UNITED STATES PATENT AND TRADEMARK OFFICE

APPLICATION NO.	FILING DATE	FIRST NAMED INVENTOR	ATTORNEY DOCKET NO.	CONFIRMATION NO.
10/757,629	01/14/2004	Mark James Kline	8194C	4664
27752	7590	05/03/2005	EXAMINER	
THE PROCTER & GAMBLE COMPANY INTELLECTUAL PROPERTY DIVISION WINTON HILL TECHNICAL CENTER - BOX 161 6110 CENTER HILL AVENUE CINCINNATI, OH 45224			HILL, LAURA C	
			ART UNIT	PAPER NUMBER
			3761

Office Action Summary

DETAILED ACTION

FIG. 1

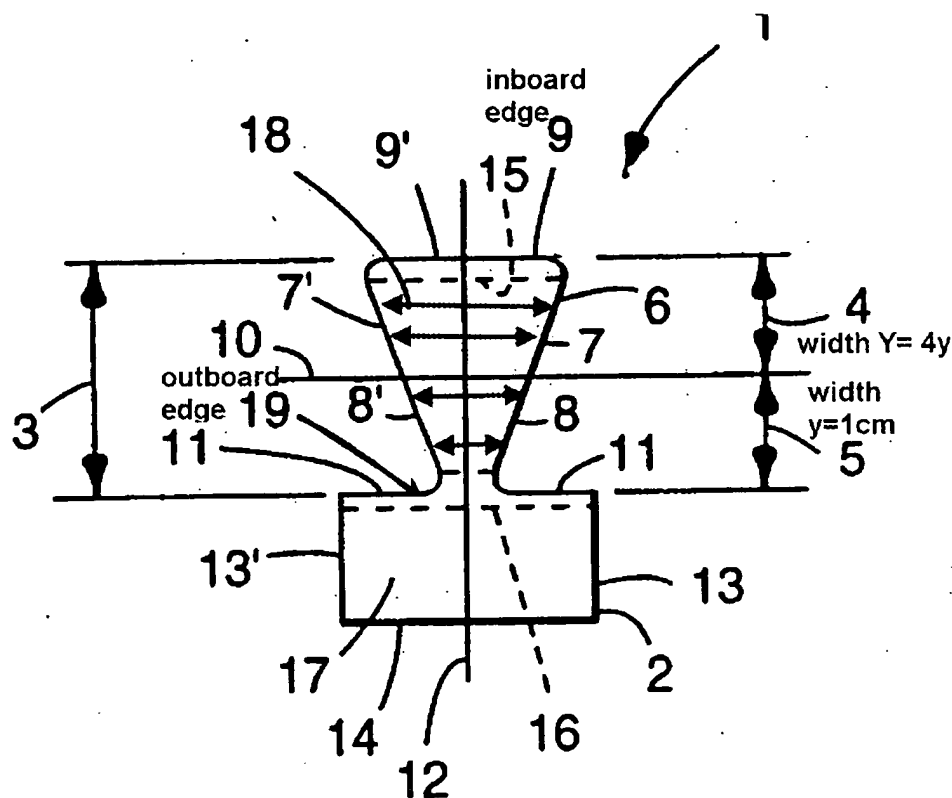
1. Claims 1-9 rejected under 35 U.S.C. 102(b) as being anticipated by Rossini et al. (US 5,312,387). Regarding claims 1-2 and 9 Rossini et al. discloses a diaper fastening tab 1 having a bond end 2 joined to article side edge and a free end 3 with a fastening surface 18, the fastening tab 1 having an effective dimension Y extending parallel to a longitudinal axis, the effective dimension Y increasing from a laterally outboard edge 19 to a laterally inboard edge 9 of the first surface, wherein the surface fastening system has peel maximum/different levels of resistance to disengagement at the distal half 4 of free end 3 (col. 2, ll. 31-39, 43-47, col. 4, ll. 1-8 and figure 1).

Regarding claims 3-4 Rossini et al. discloses a fastening element with a longitudinally inboard edge 9 longer than longitudinally outboard edge 19 (fig. 1).

Regarding claim 5 Rossini et al. discloses inboard edge 9 having free end 3 being unjoined from the article (col. 2, ll. 43-45 and fig. 1).
